Bid Bulletin No. 2
20 November 2020

PUBLIC BIDDING No. 20-038-1

Construction of New Clark City Connecting Road to Industrial Park

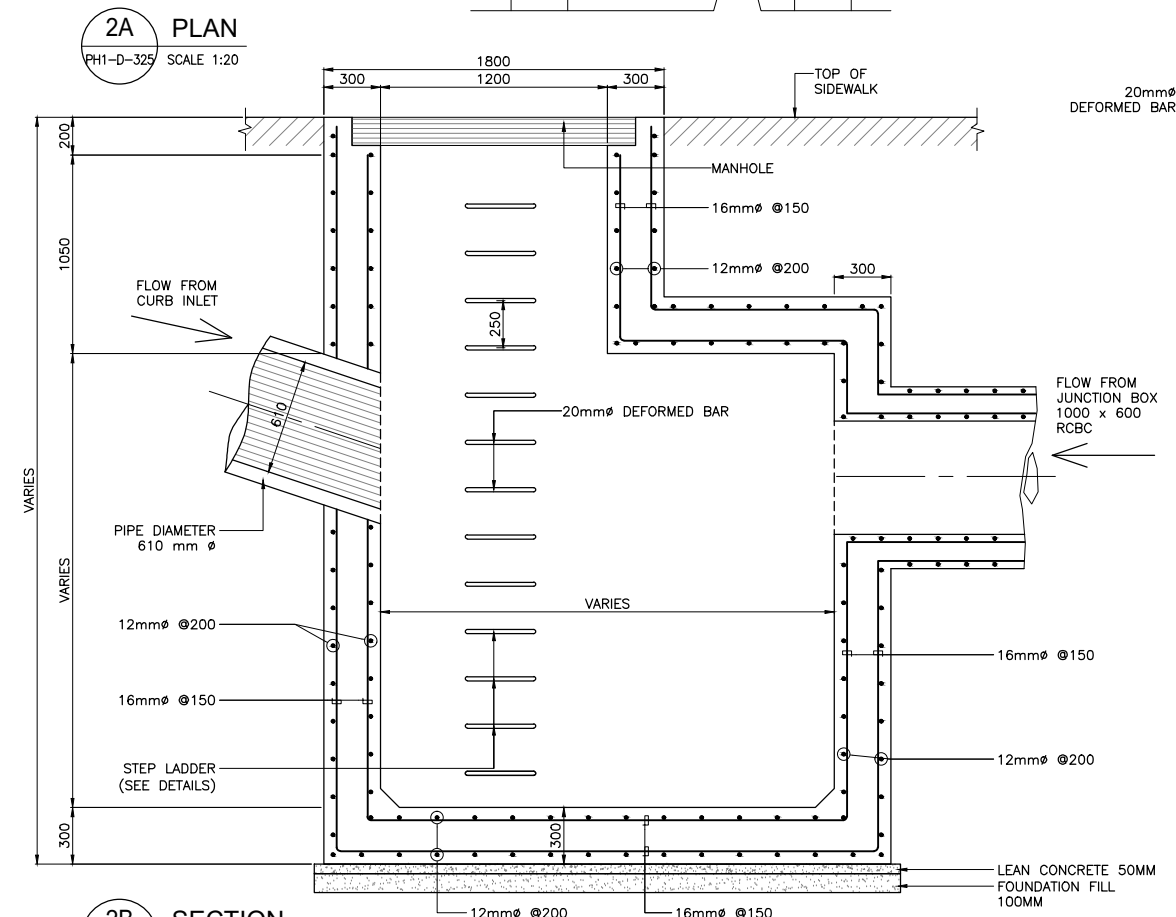
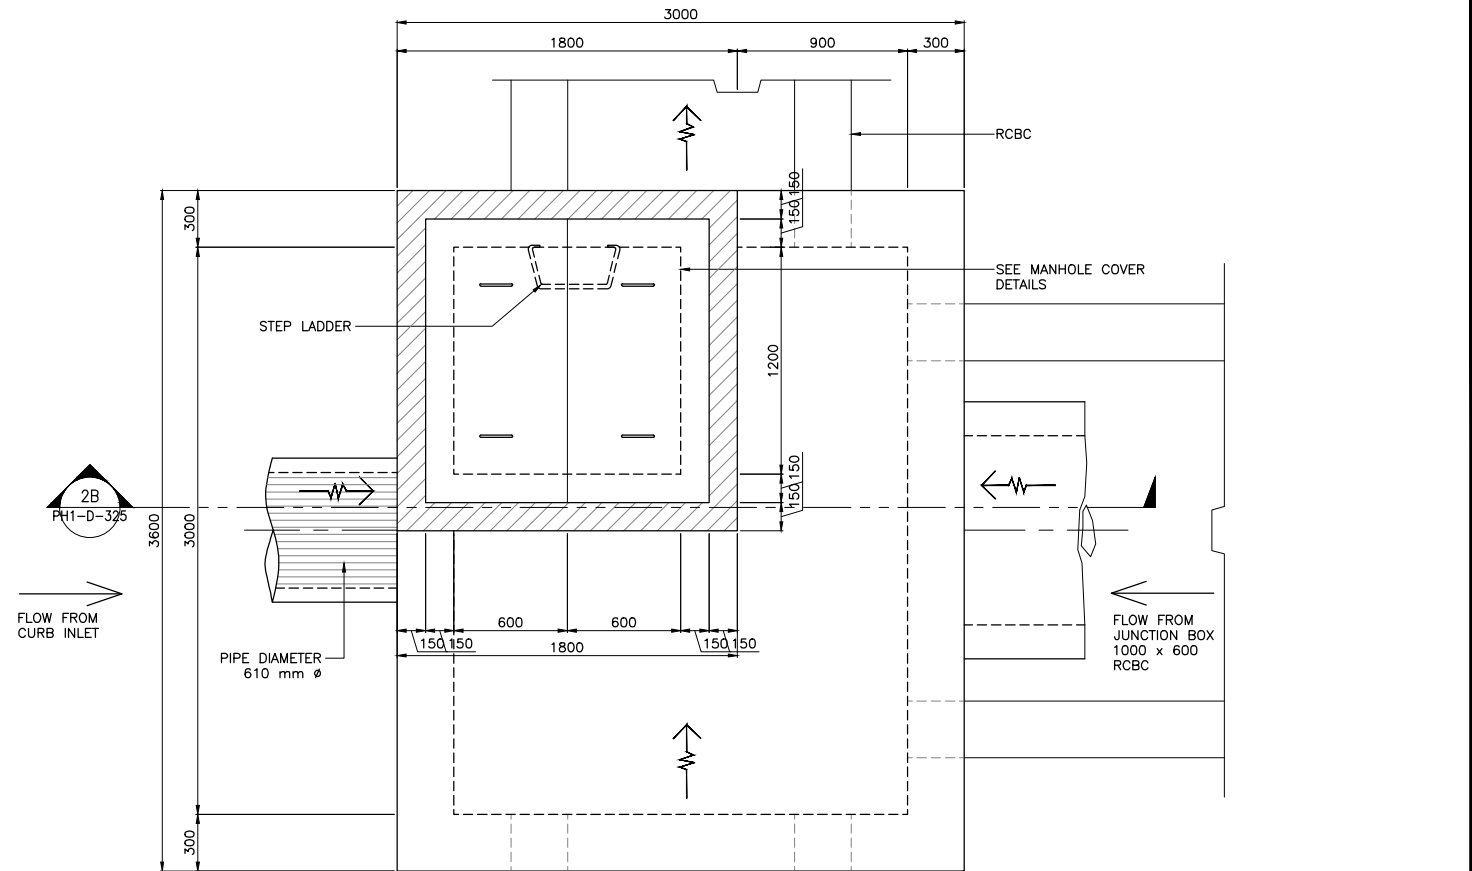
target completion of the project.	
18	We would like to clarify if BCDA will provide a lot area near the project site for facilities of the winning contractor free of rental charge?	Facilities for the Winning Contractor	<i>Yes. BCDA shall determine the location of the site area for the use of Contractor, free of charge. However, all the contractor's temporary facilities, required works, necessary permits, application and payment for utilities shall be at the cost of the Contractor.</i>
19	Kindly confirm that the reinforcement and thickness of the wall and slab for the lateral RCBC will be the same as to the tabulation provided for the Single Barrel Box Culvert?	Part G: Drainage and Slope Protection Storm Drain (RCBC Type)	<i>Details are the same with the details provided for Single Barrel RCBC.</i>
20	Kindly provide us of the detailed plan of the manhole	Manhole There are eleven (11) types of manhole in the given Bill of Quantities, however, the given plan for the manhole is incomplete and no details for reinforcement, wall thickness, etc	<i>Please see attached revised Drawing No. PH1-D-325 attached as Annex A.</i>

1 CURB INLET DETAIL
PH1-D-325 SCALE 1:20

2 DETAILS OF BOX CULVERT MANHOLE
PH1-D-325 SCALE 1:20

ANNEX B

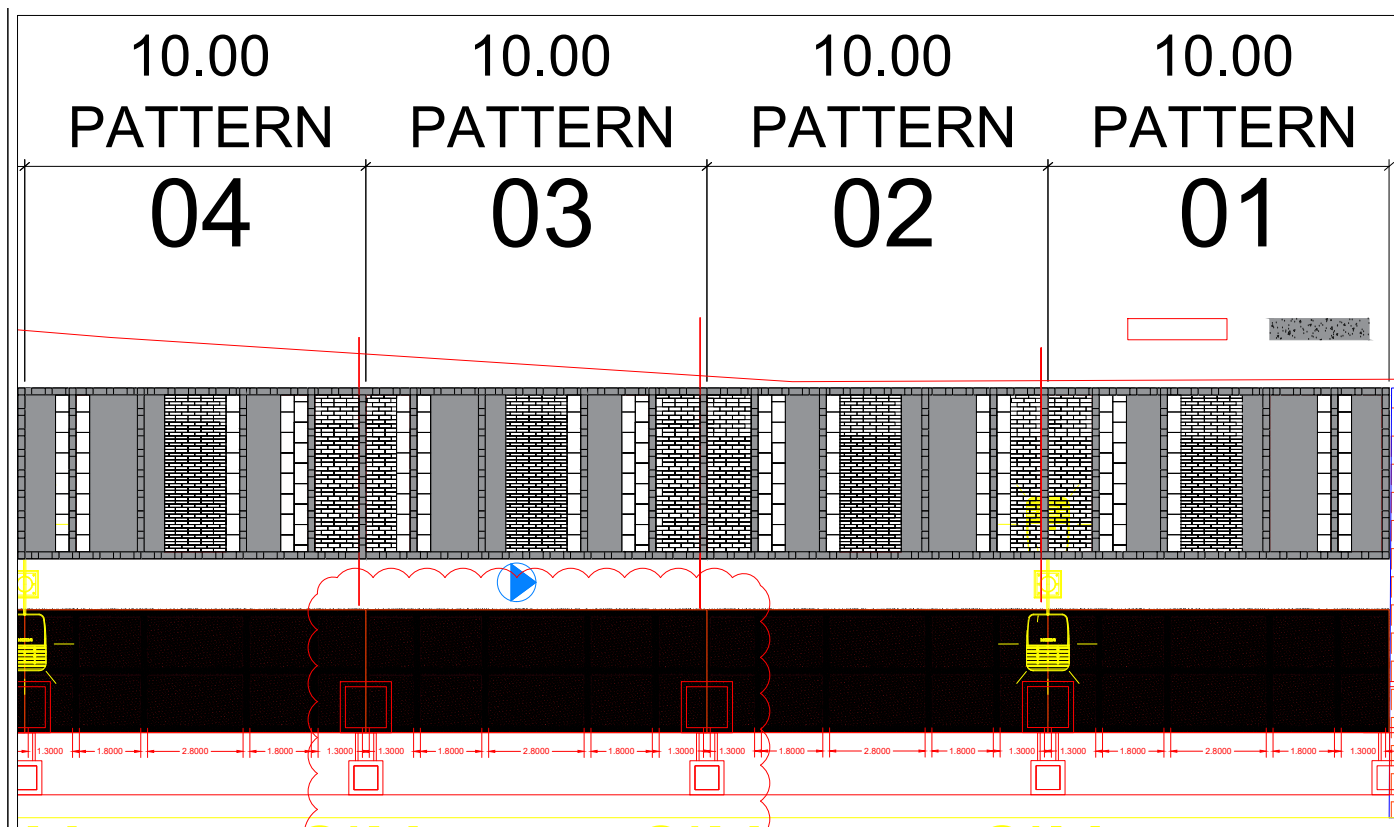
21	We noted that in the Bill of Quantities for Waterway Channel, there is no pay item of Structure Excavation. Please clarify.	Waterway Channel, Sta 0+00 to Sta 1+200 (L=1,288.32)	<i>The quantity for the channel excavation is included in the Roadway Excavation quantities.</i>
22	1. Since the Stamped Concrete pattern and color will follow the Pedestrian/Sidewalk already constructed in new Clark City, may we request for the sample plan of	Part H. Miscellaneous Structures SPL 601(2)1	<i>1. Please see illustration attached as Annex B.</i>

PROPOSED BIKEWAY FINISH
SCALE NTS

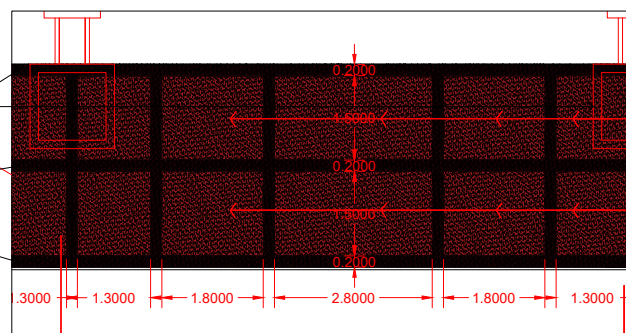
<p>completed section for our reference?</p> <p>2. Kindly confirm that the reinforcement is 10mm dia. at 400mm spacing bothways for sidewalk and bike lane.</p> <p>3. Kindly indicate in the plan the location of the expansion joint filler 5mm thick and the control joints.</p> <p>4. Kindly provide us also the plan for Bike Lane paving with Sand Washed Finished Texture including the details and spacing of required diamond dowels to provide load transfer.</p> <p>5. Kindly provide us also the Section details showing the thickness of concrete, thickness of sand washed or stamped concrete for bike lane paving and sidewalk paving</p>	<p>Sidewalk/Pedestrian Lane Paving (Reinforced) 100mm thick with Stamped Concrete Finished Texture</p> <p>SPL 601(2)2 Bike Lane Paving (Reinforced) 100mm thick with Sand Washed Finished Texture</p>	<p>2. The reinforcement is 10mm diameter at 400mm spacing both ways.</p> <p>3. Please see illustration attached as Annex C.</p> <p>4. Please see Bikeway Finish attached as Annex D.</p> <p>5. Please see Bikeway Finish attached as Annex C.</p>

WIDE BIKEWAY PAVING BANDING
PROPOSED SUBSTITUTE TO GLOW IN THE DARK AND $\frac{3}{8}$ GRAVEL FINISH
INTEGRAL CONCRETE
MEDIUM SANDWASH FINISH (3000 PSI)
0.20M

Bomanite System: Sandwash Finish
Color Description:
Color Hardener: Currant Red
Integral Color: Berry Red
Deactivator: Standard
Sealer Process:
1. Conshield
2. Bomanite Premium SB Sealer

ANNEX E

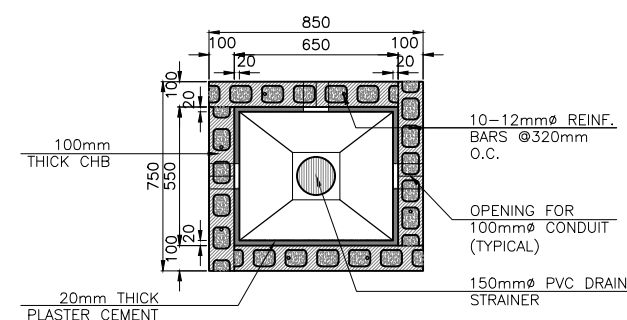
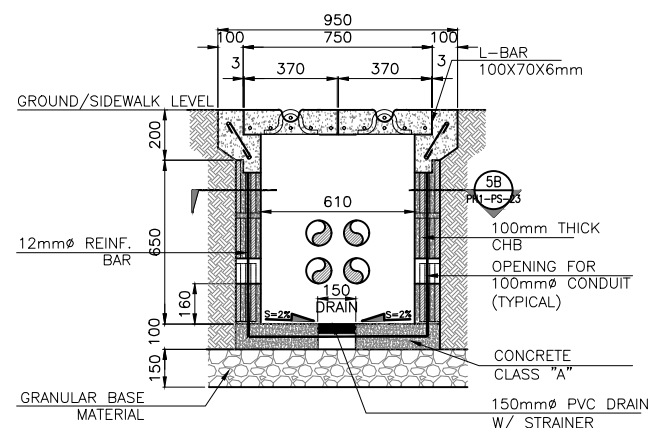
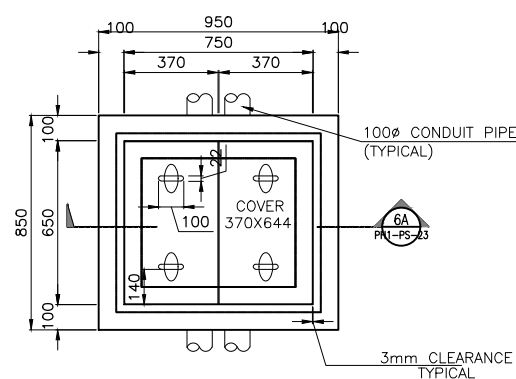
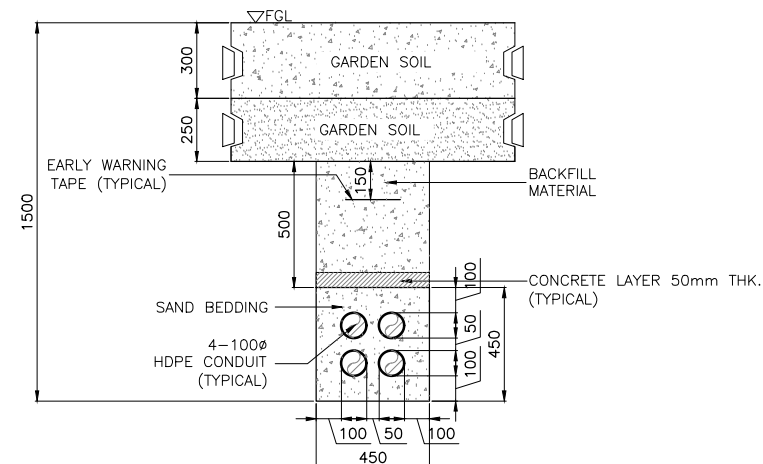
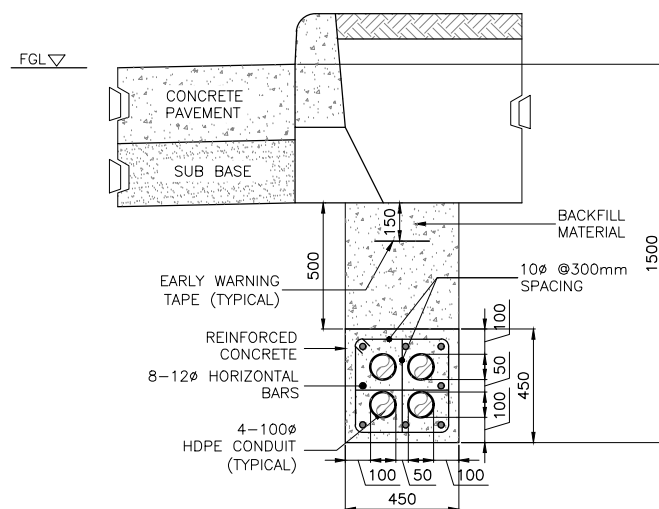
23	<p>1. Kindly confirm that in lieu of sand bedding it will be concrete encasement since this is for road crossing</p> <p>2. What is the concrete compressive strength of concrete encasement?</p> <p>3. Kindly provide us the detail of reinforcement for concrete encasement which are not included in the given plan</p> <p>4. Kindly confirm also that the concrete tile 50mm thick x 250mm W x 250mm L is unreinforced</p>	<p>Part J. Roadway Lighting</p> <p>Concrete Encasement (Reinforced)</p> <p>Item 624(8)b1 Duct Banks (Concrete Encasement) 10.0m Single and Double Arm Pole for Road Crossing</p> <p>Based on the given drawing detail 4 of PHI-PS-21, the scope of works include excavation</p>	<p>1. Ducting for road crossing is concrete encased.</p> <p>2. 20.68MPa shall be used.</p> <p>3. Please see revised Drawing No. PH1-PS-23 attached as Annex E.</p> <p>4. Concrete tile is plain concrete.</p>

1. Landscaping Drawings 2. Living quarters and laboratory for the engineer		drawings PH1-LS-01 to PH1-LS-09. 2.The living quarters and laboratory shall be constructed in accordance with the location, floor plans and drawings prepared by the Contractor and approved by the Engineer
28	Please provide the following drawings: 1. PH1-D-292 (Curb Inlet, Box Culvert & Junction Box Details) 2. PH1-D-295 (Typical Culvert and Curb Inlet Details) 3. PH1-D-298 (Waterway General Plan)	Drainage System	1. Please see revised Drawing No. PH1-D-325 attached as Annex A. 2. Please see revised Drawing No. PH1-D-325 attached as Annex A. 3. Please refer to the drawing PH-D-328.
29	Type of XLPE Cables, shielded or unshielded?	Electrical Works	Unshielded
30	Can we offer integrated LED fixtures against conventional type as per requirements?	Electrical Works	The requirement is Integrated LED Fixtures.
31	Can you provide foundation detail of Panel Foundation pad?	Electrical Works	Please see drawing PS1-PS-23 attached as Annex E.

6M DOUBLE ARM POLE
LOW VOLTAGE DUCTBANK DETAIL
FOR ROAD CROSSING – ROAD LIGHTING CABLE

10M SINGLE AND DOUBLE ARM POLE
LOW VOLTAGE POWER CABLE IN REINFORCED CONCRETE
(FOR ROAD CROSSING)

6 LIGHTING DISTRIBUTION PANEL
FOUNDATION PAD DETAIL
PH1-PS-23 SCALE 1:15
